Subject: **Vermont Yankee Nuclear Power Station**
Revision 1 to Steam Dryer Monitoring Plan

Attachment 1 includes a revision (Revision 1) to the Steam Dryer Monitoring Plan (SDMP) that was previously provided in Reference 2. The SDMP will remain in effect until License Condition 3.M expires. The SDMP, together with the EPU Power Ascension Test Procedure (PATP) provides for monitoring, inspecting, evaluating, and prompt action in response to potential adverse flow effects on the steam dryer as a result of power uprate operation. These actions provide assurance of the continued structural integrity of the steam dryer under Extended Power Uprate conditions. Attachment 2 provides the justification, consistent with License Condition 3.M.4 for why this change does not require prior NRC approval.

Steam Dryer Monitoring Plan

Revision 1

Figure 1: Steam Dryer Stress Limit Curve – MSL 'A' Upper

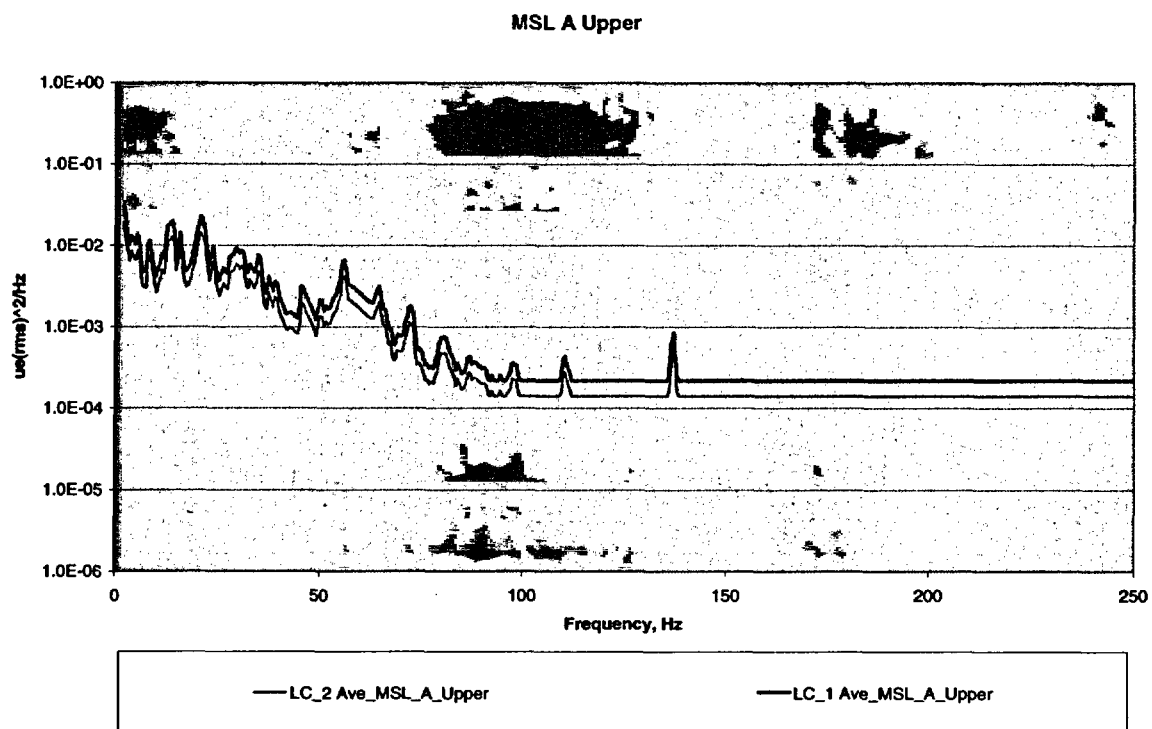
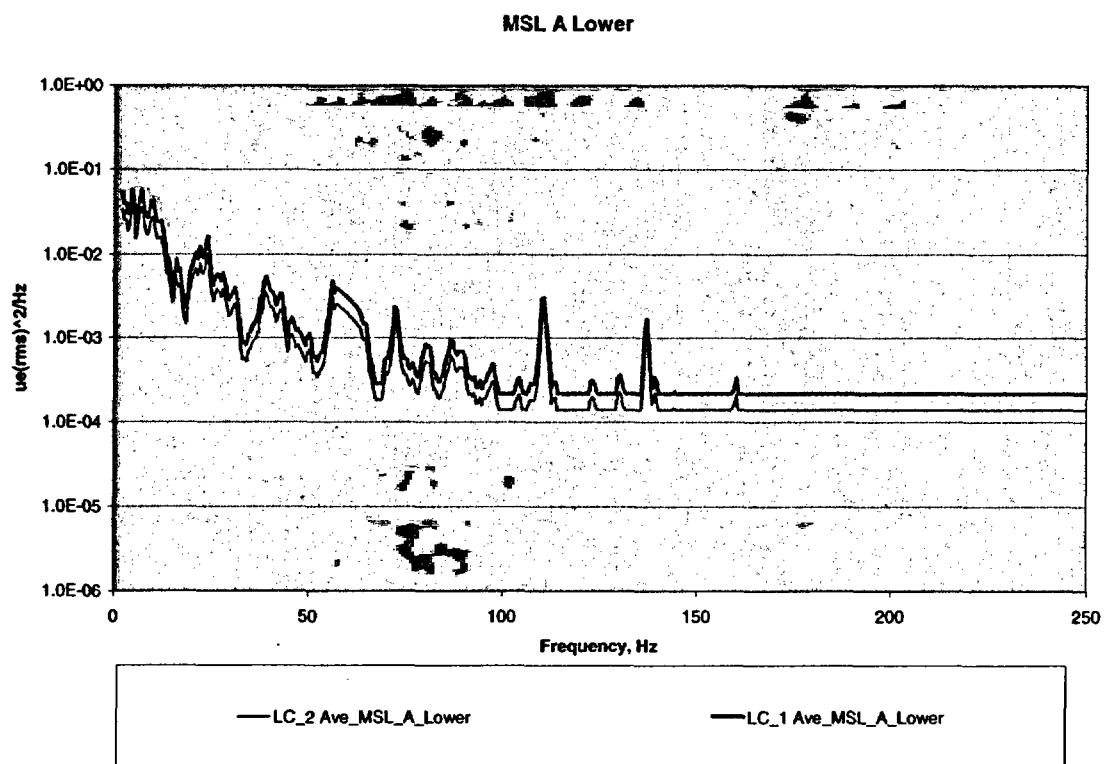
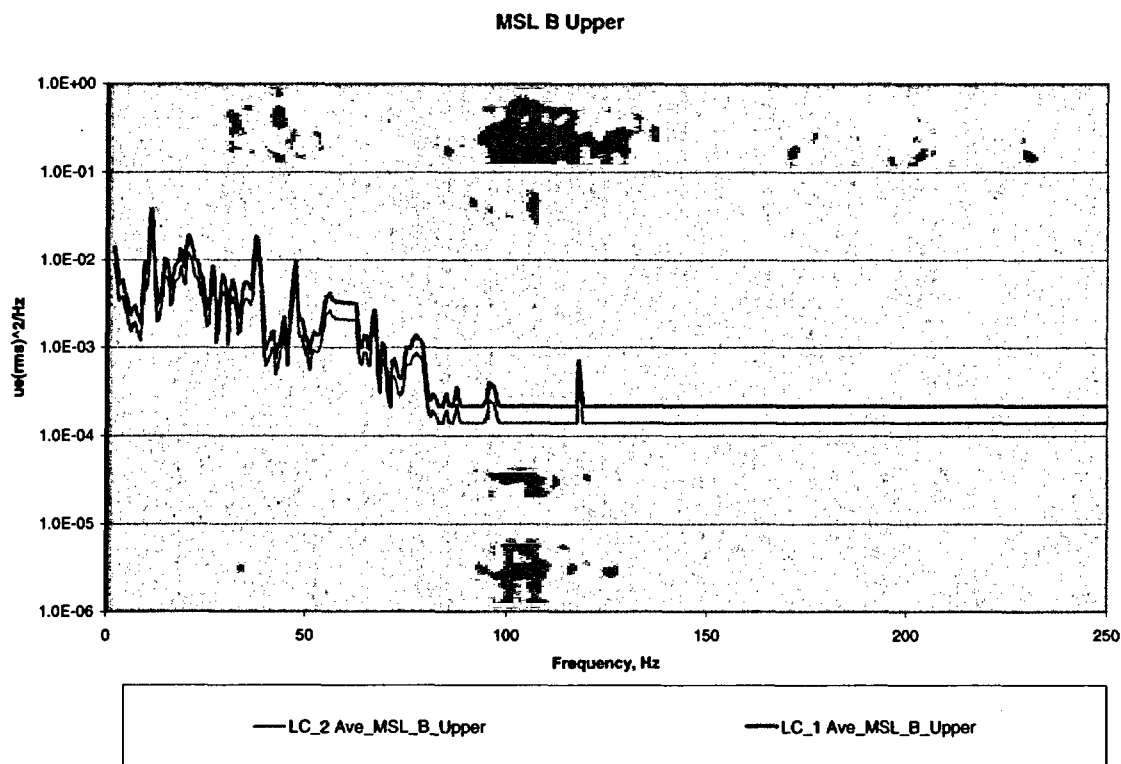
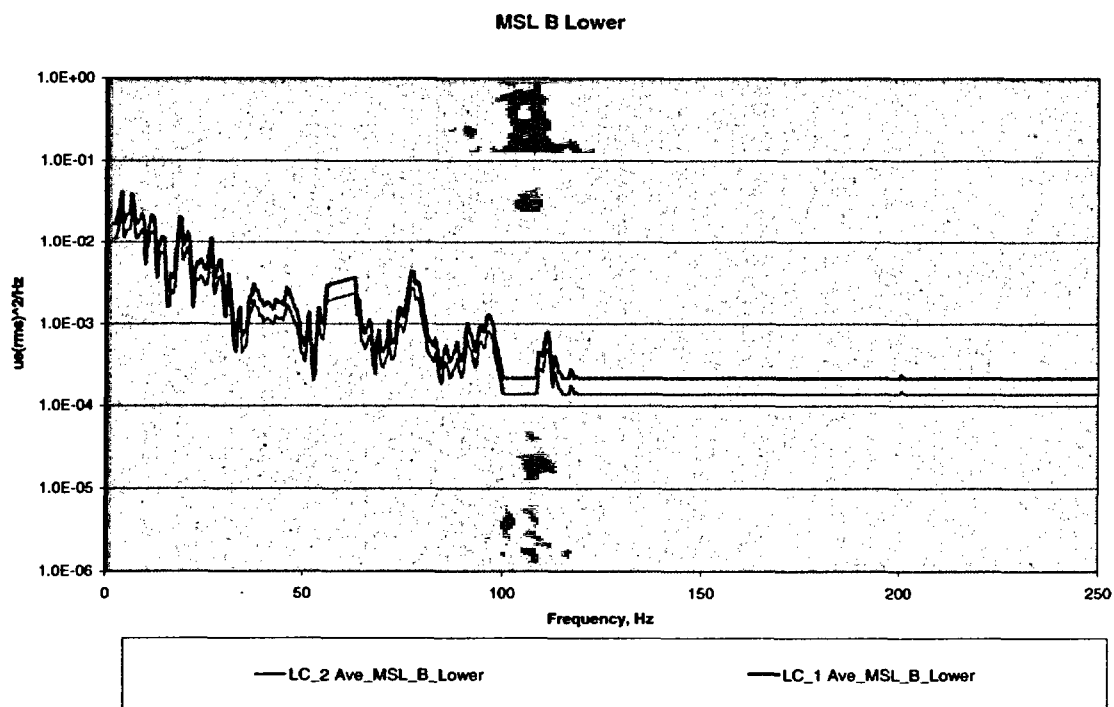
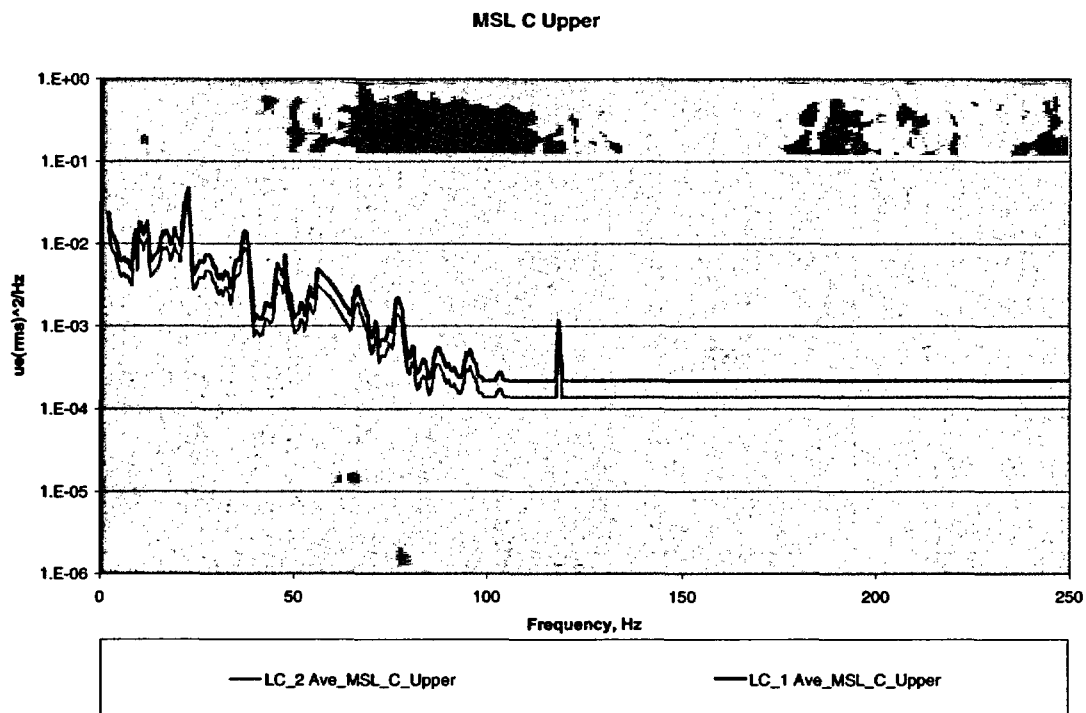
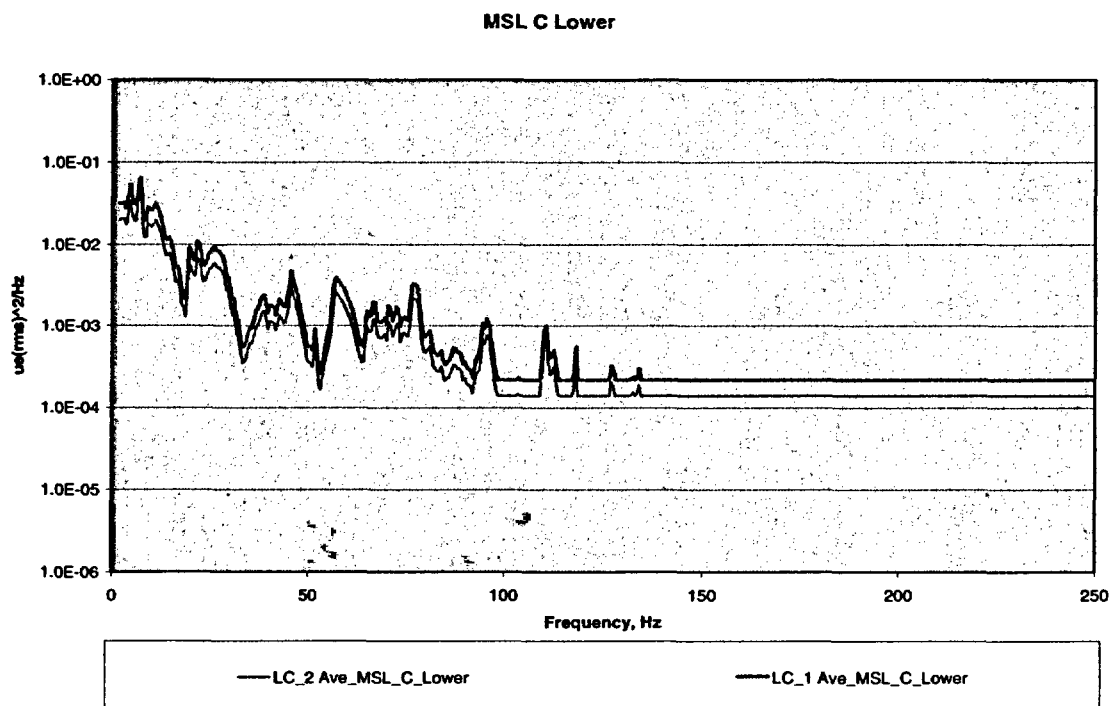
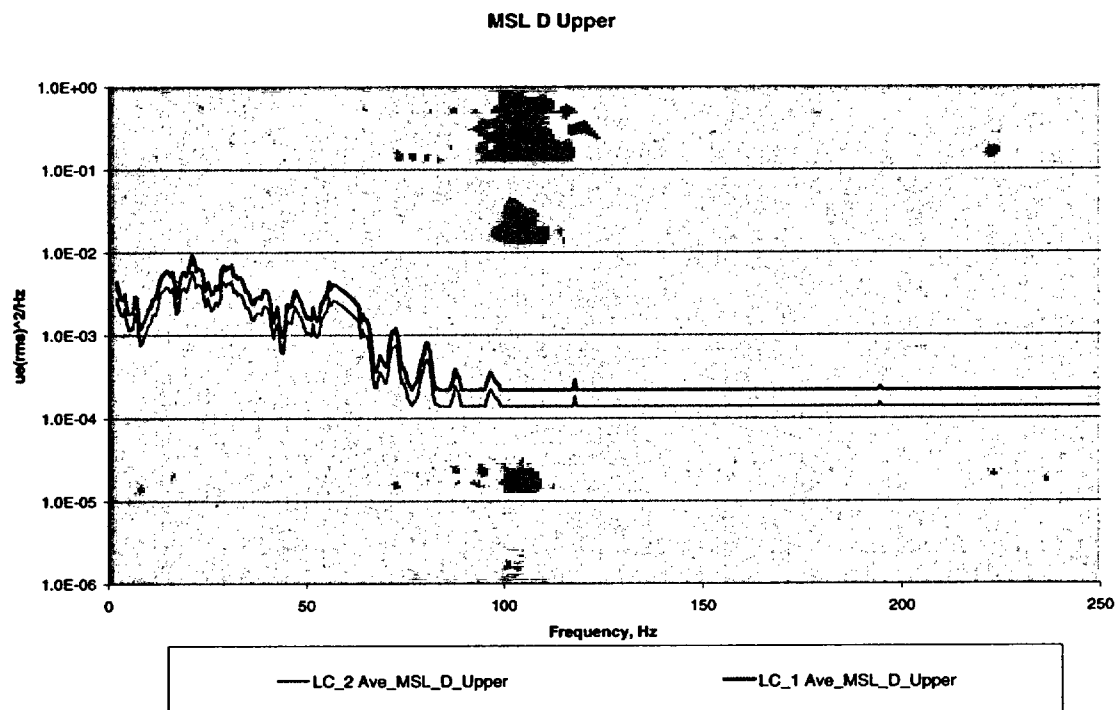
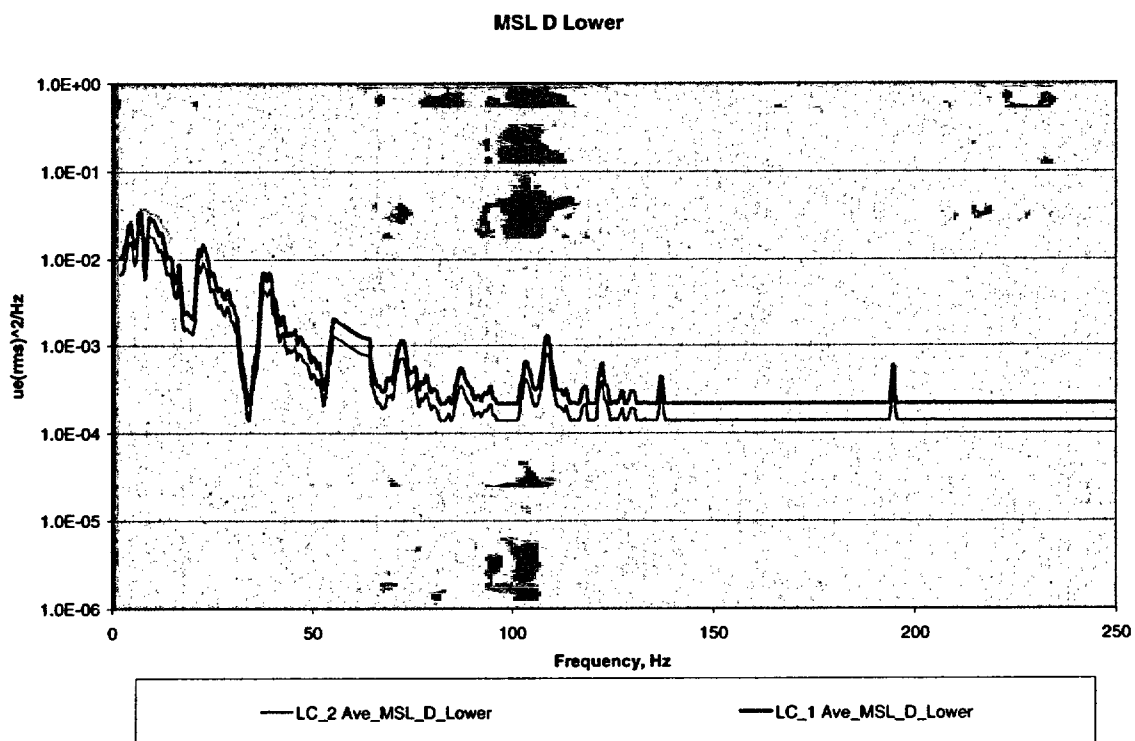
- The strain gage data collected hourly during power ascension will be compared against the stress limit curve that is provided as Figures 1 - 8 of the SDMP and is based on Entergy Calculation VYC-3001. If any frequency peak from the MSL strain gage data exceeds the stress limit curve (Level 1), Entergy will reduce the reactor power to a level at which the stress limit curve is not exceeded.

4. Generation of a new Uncertainty Calculation based on plant data and the changes above as required by the License Condition.
5. An updated Level 1 Limit Curve representing a conservative reduction of the ASME design limit (13.6 ksi) by the values obtained in the uncertainty assessment.

- a. This revision proposes no change in the test plateau increments from those specified in the criteria.
- b. The Level 1 performance criteria is defined as a limit curve for strain gage results that represents a stress on the dryer equal to the ASME Design Limit of 13.6 ksi minus the calculated total model and measurement uncertainty.

The application of model refinements that provide for higher accuracy in determining Vermont Yankee specific dryer stress limits does not constitute a change in methodology. The updated limit curves still represent the ASME criteria minus the calculated uncertainty.
